**Re: Proposed Official Plan Amendment
Hazelview Developments Inc.
11160 Yonge Street
City File Nos.: D01-20013 and D02-20025
York Region File Nos.: LOPA.20.R.0075 and ZBA.20.R.0141**

This is in response to your circulation and request for comments for the above-captioned Official Plan Amendment (OPA) application and Zoning By-law Amendment application.

Development Engineering

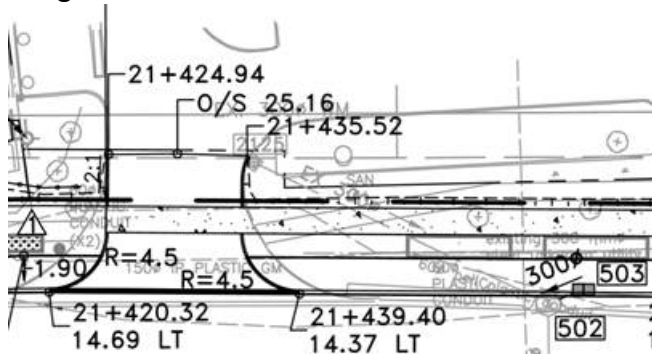
1. It should be noted that the concept plans do not reflect the Region's 22.5m right-of-way requirement, measured from the centerline of construction of Yonge Street.
